**PLANNING & COMMUNITY DEVELOPMENT DEPARTMENT**  
**Land Use Review Division**

**RE: Administrative Decision for the Wahsatch Ave Transit Mix US-CO 5068 CMRS Plan**  
**File Number: AR CM2 18-00636**

Re: 444 East Costilla Street: File No. AR CM2 18-00636

Figure 2 – Approximate location of monopine on top of large retaining wall (tree height approximate but not to scale)

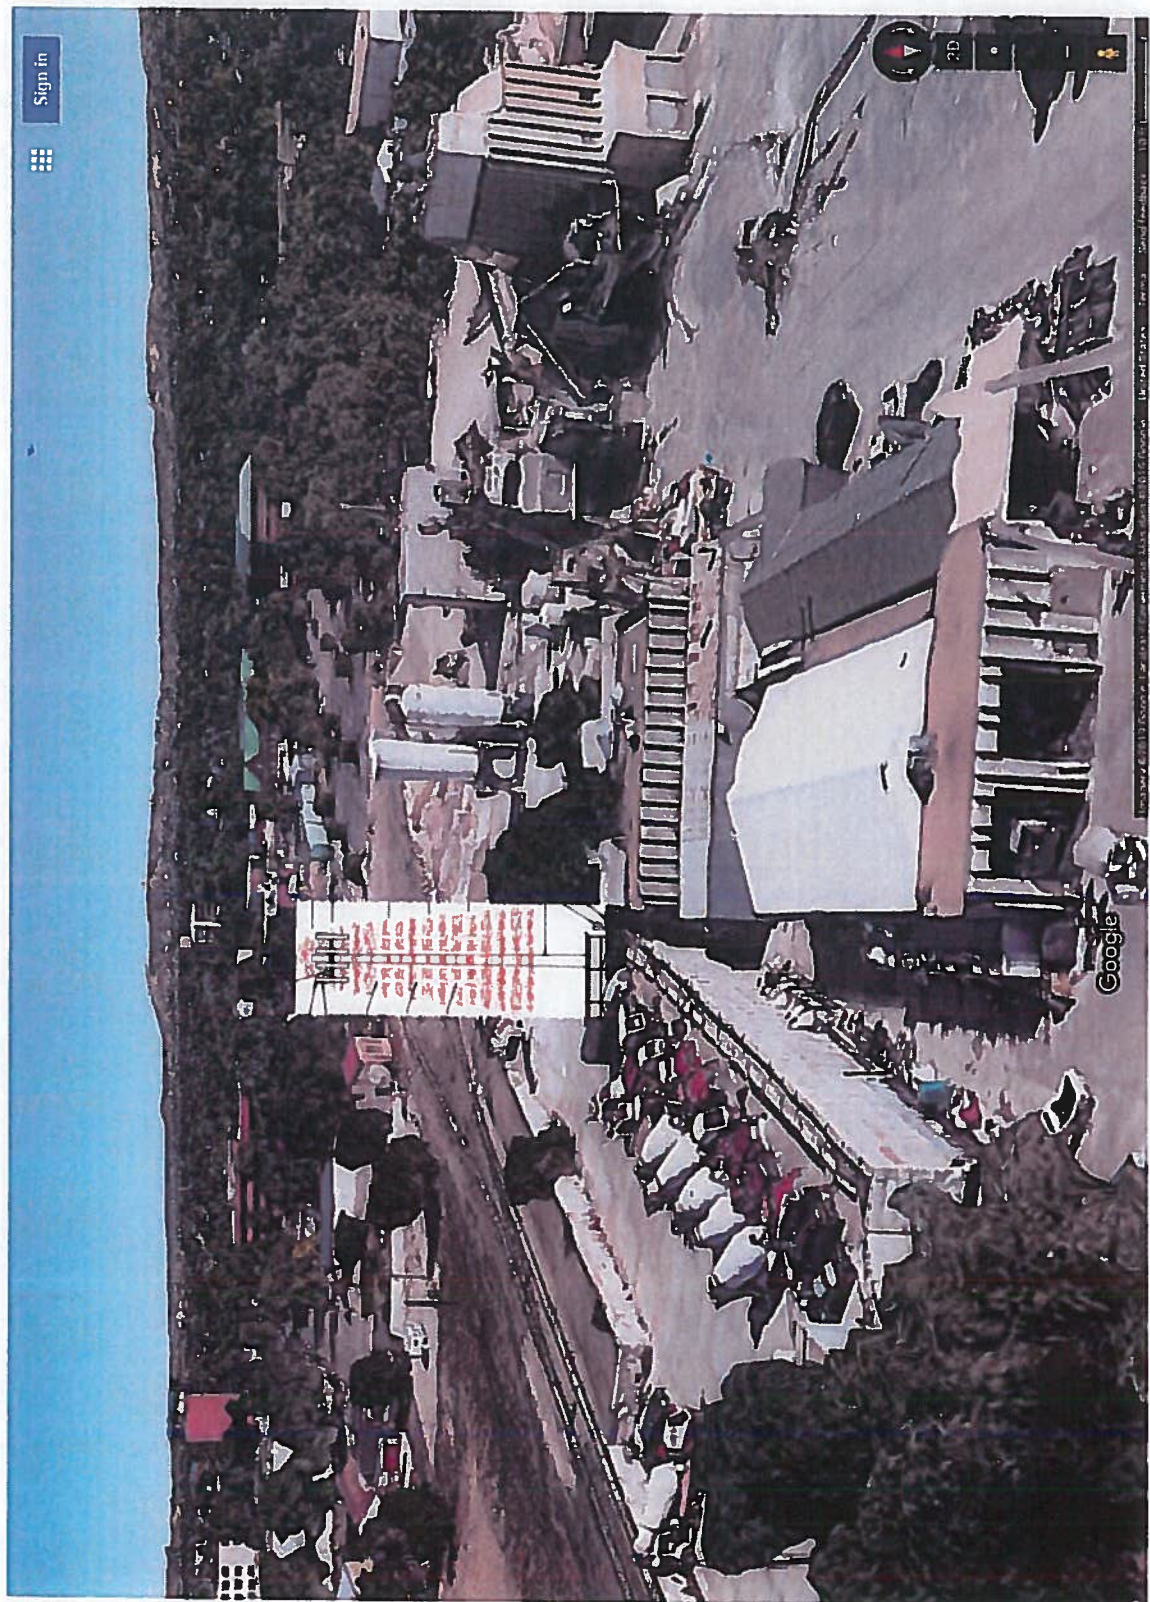
Further, City Staff finds that the proposed location does not provide the greatest screening potential. In fact, the site is located at the top of a roughly fifteen foot (15') high retaining wall which results in the facility being prominently exposed from all directions. None of the land survey sheets within the proposed plan include topographic information documenting this fact. Figure 2 is a Staff produced exhibit illustrating the proposed location of the facility using Google's publically available 3D imagery; while the proposed monopine is not to scale on the figure it represents approximate location and height relative to the surrounding area.

VIEW 1 | LOOKING WEST

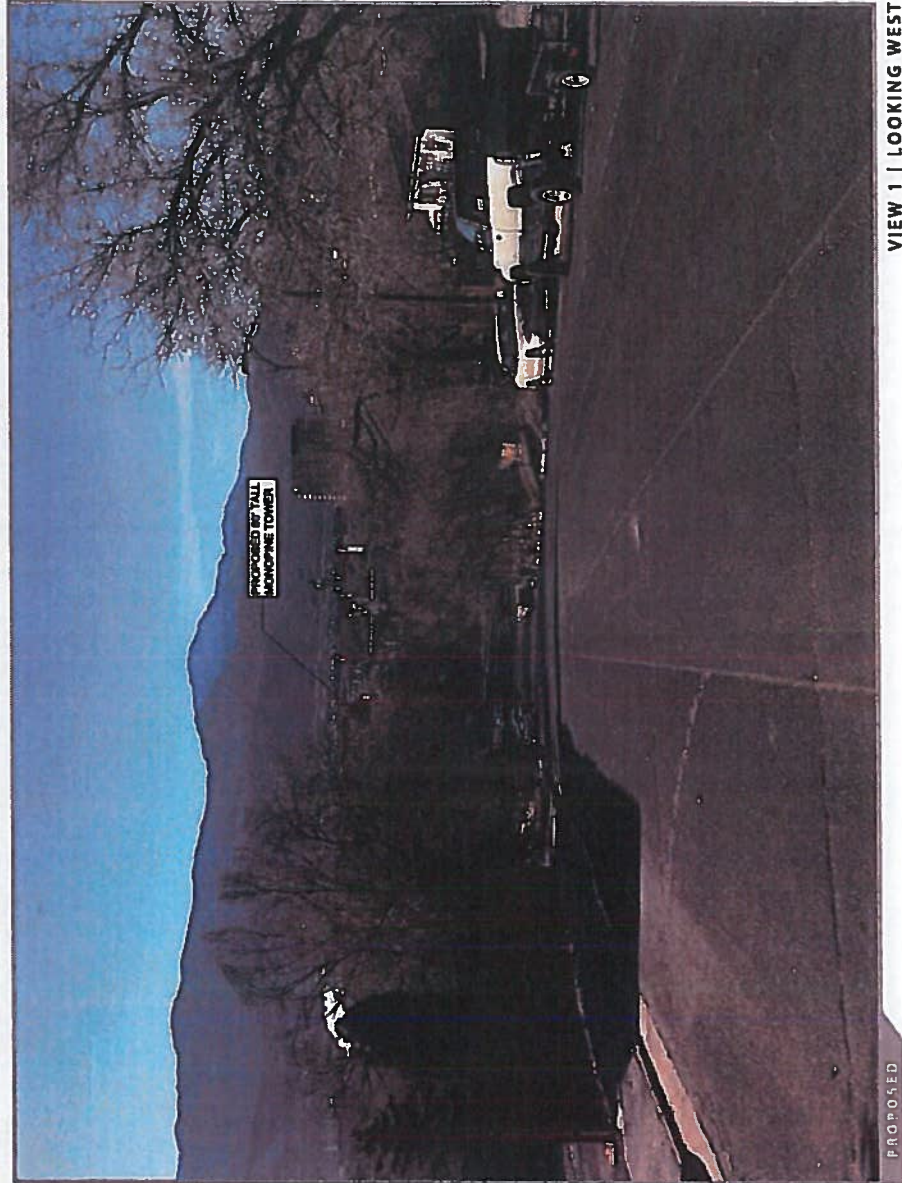
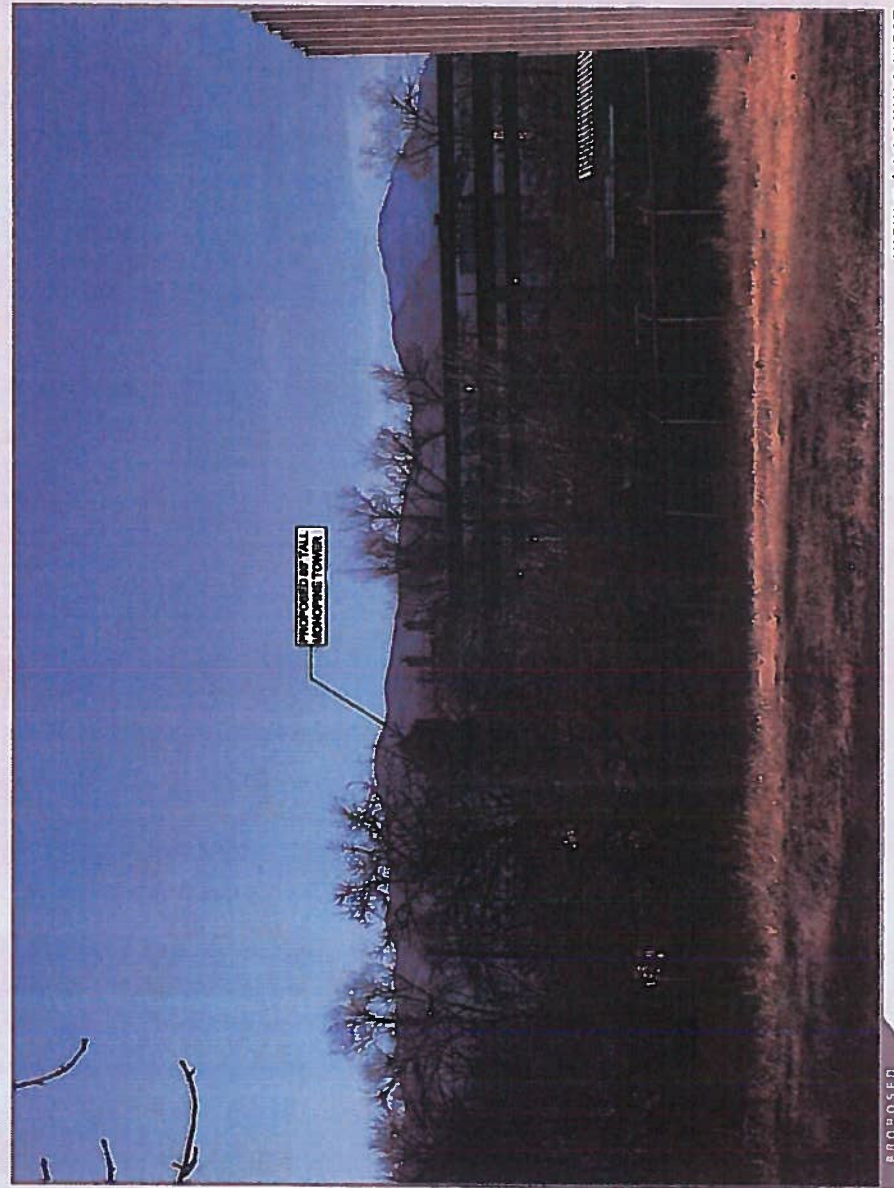
Further, the proposed mono-pine design and the location of the facility on the site are architecturally and visually incompatible with the surrounding area. Where Code requires integration, the proposed location and design are disconnected from the context of the area. The height and scale of the structure combined with the fact that it is located on the highest part of the site will create a conspicuous and glaring intrusion into the public viewsheds from both the east and the west. While Staff has emphasized the need for photo-simulations from the east looking west, Staff has consistently and repeatedly requested photo-simulations from all four directions (Figure 4 - Pre-application Notes dated 7/11/18 and Figure 5 - Review Letter dated October 9, 2018). Only photo-simulations looking west were ever provided.

Figure 29: Detailed Segment #3 - Urban Waterway  
(Option 1 this page, Option 2 next page)

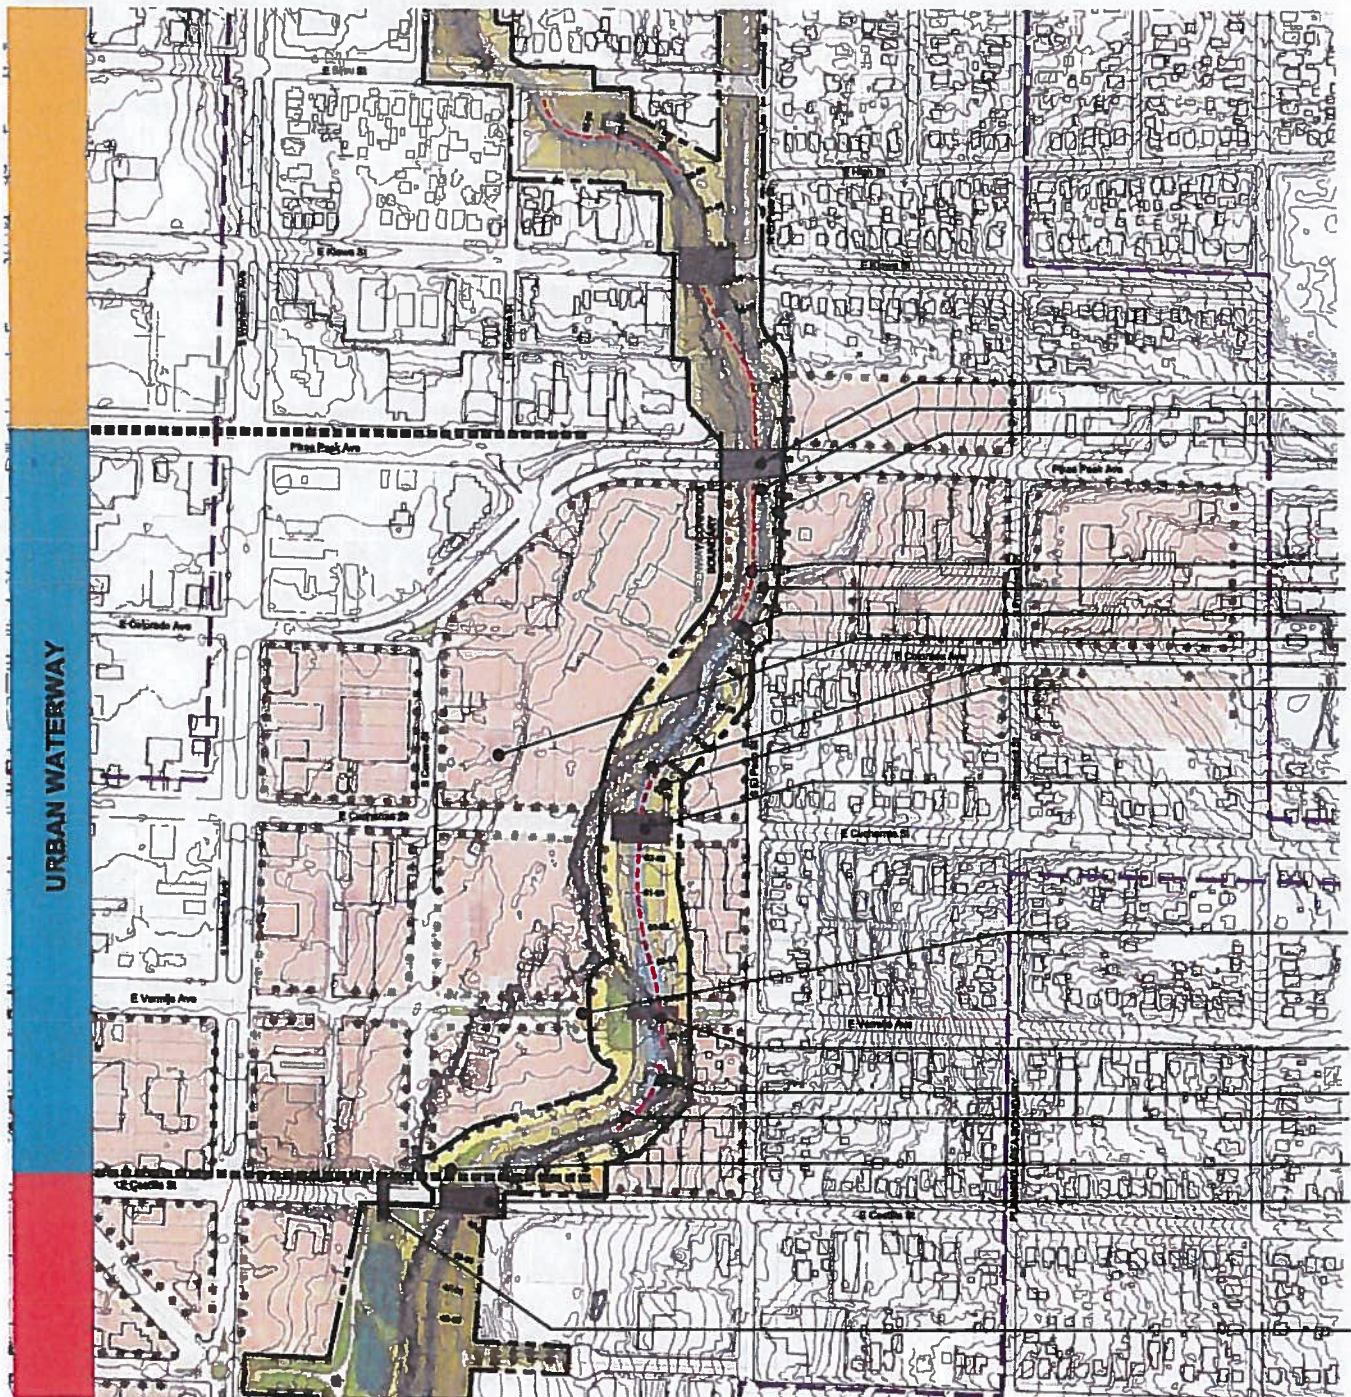
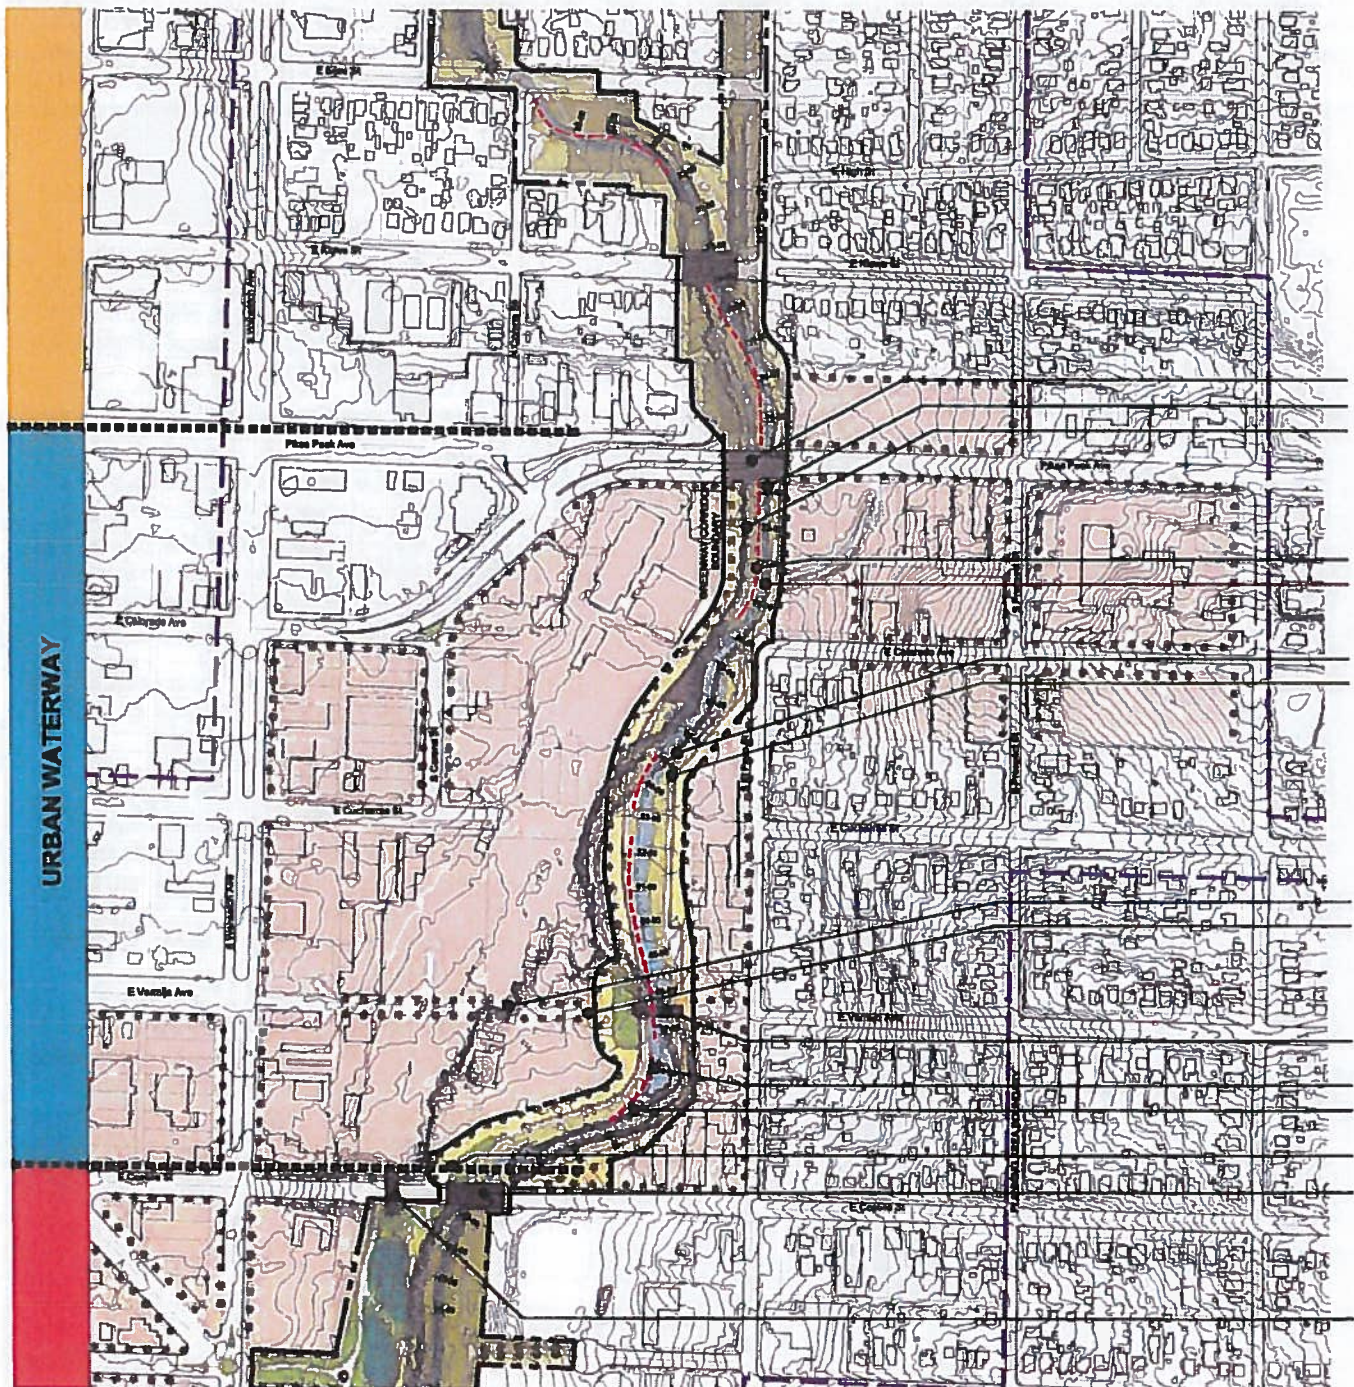
In February of 2017 City Council approved Resolution 18-17 which adopted the Envision Shooks Run Facilities Master Plan (ESFMP). The ESFMP includes detailed maps, graphics and text describing the future of the Shooks Run segments. The subject property falls squarely within the Urban Waterway Segment described on pages 70-77 of the plan (Figure 6). Specifically, the Plan calls for future extension of Vermijo Ave. eastward towards the creek terminating in an "urban space entry" feature. The proposed site of the CMRS facility obstructs the proposed extension of Vermijo Ave. As such, Staff finds that the proposed facility does not substantially comply with the ESFMP. Further information on the ESFMP is available at [www.envisionshooksrun.com](http://www.envisionshooksrun.com) or through the City planning department.
